GFA AIRWORTHINESS DIRECTIVE

TYPE AFFECTED: K 8, K 8B, K 8C. All models all serial numbers including kit or licence built gliders.

GFA AD 459	ISSUE: 1	21 October, 1996	Page 2 of 6
-------------------	-----------------	-------------------------	--------------------

Fußsteuer L-216.42-401

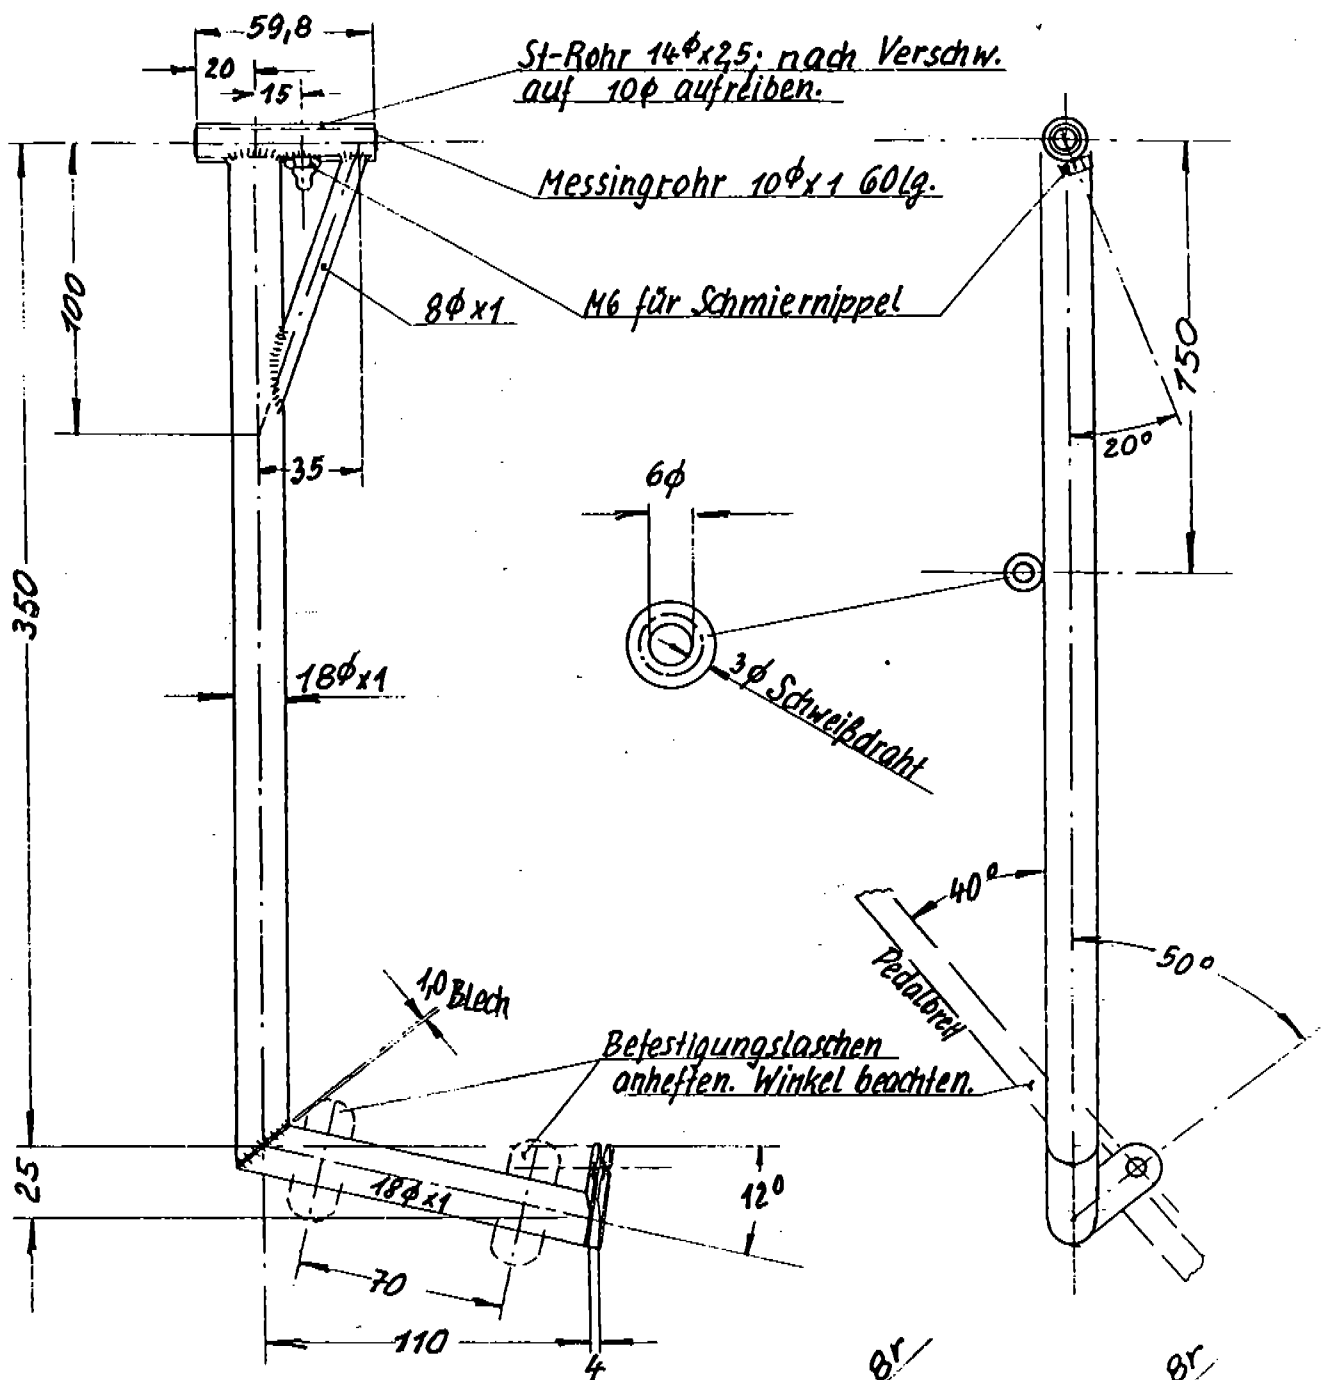
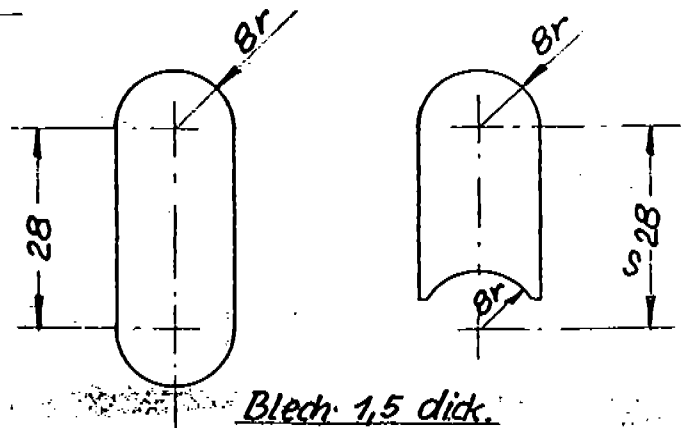
SHEET: 3 of 4	K 8 Technical Note No. 24	Alexander Schleicher GmbH & Co. Segelflugzeugbau XXG 0618 Poppenhausen
new zip code: D-36163 ad B1) This Technical Note must be inserted into the Flight and Maintenance Manual K 8 as annex to "Attachments" and the insertion must be certified in the Manual. ad B2) For the maximum oversize diameters of the "attachment pins for wing, front" (AS P/N 080.11.0730) and/or "Plug-in pins for wing attachment, rear" (AS P/N 080.11.0511) please observe: the material thickness of the fitting around the bore at its thinnest section must still be at least half of the diameter of the pin! The bore in the "wing attachment fitting, front" and in the "main fitting, rear" must have H7 tolerance (off size). If tolerance is exceeded, the fittings must be replaced. Material & drawings: Any required materials and/or replacement parts may be ordered from Messrs. SCHLEICHER (Tel. +49(0)6658-890 or -8929, FAX +49(0)6658-8940) stating the glider type and the serial number of the aircraft in question. For the interior wall preservation of the tubes you may use e.g. the preservative agent "Hochdruckkonservierung ML", P/N 3762, by Messrs. VOSSCHEMIE or any equivalent product. Drawings applicable to this TN: L-216.42-U01; L-216.44-U 01; L-216.44-U 02; L-216.11-S1, Issue 17.01.1958 or L-216.11-S1, rev. of 24.11.1961, valid as of s/n. 1014. Fig. A2 Reinforcing the attachment collars for pedal boards at the pedal assembly. Material: 1.7734.4 Welding procedure WIG to spec DIN 1912, welding wire material: 1.7734.2

Höhenst.-Stoßstange (hinten) L-216.44 - U02

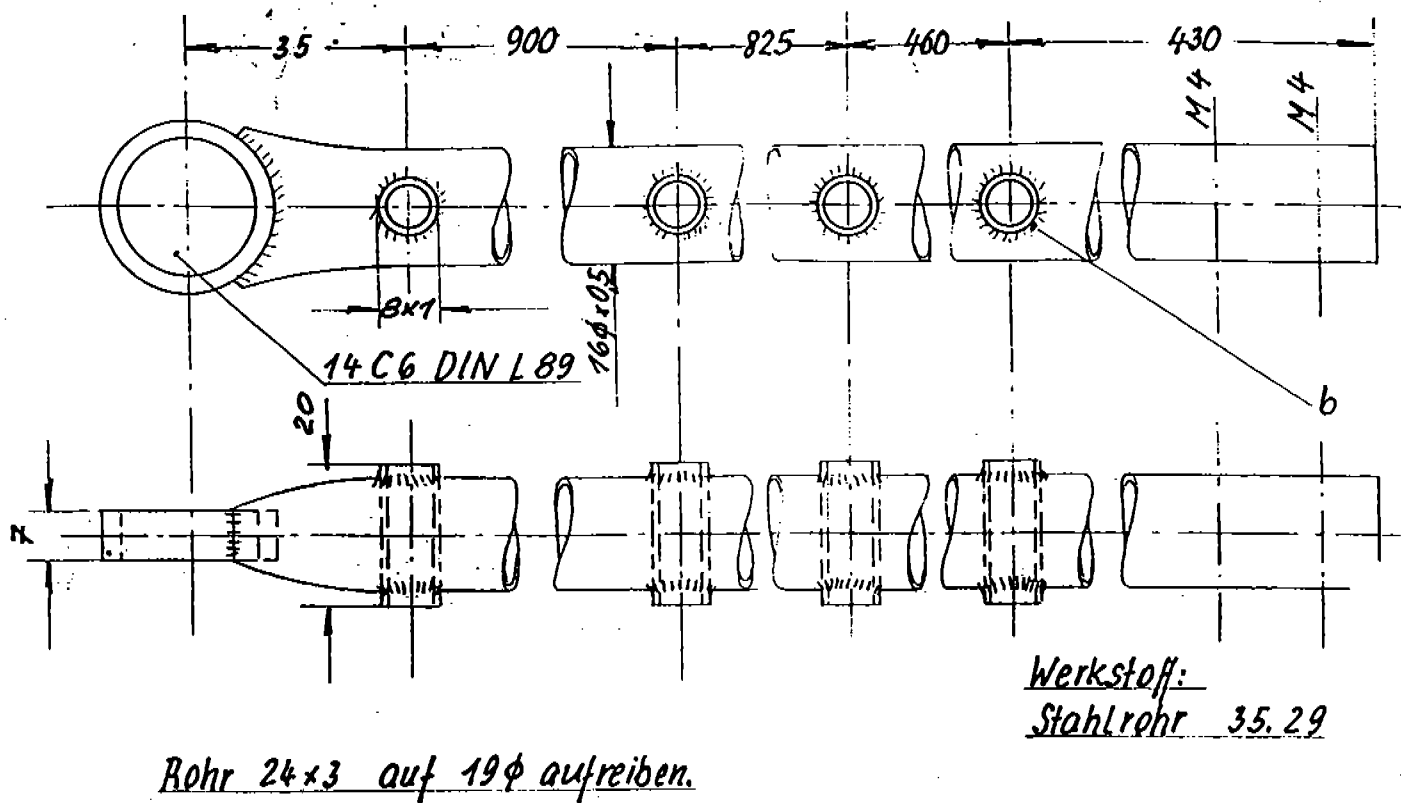
1. At each Annual Inspection ensure that the correct weak link in the canopy retaining chord is installed as per Action A1 in K 8 Technical Note No. 24.
2. At each Annual Inspection inspect the rudder pedals in accordance with Action A2 of K 8 Technical Note No. 24.
3. At each Annual Inspection inspect the elevator pushrods in accordance with Action A3 of K 8 Technical Note No. 24.
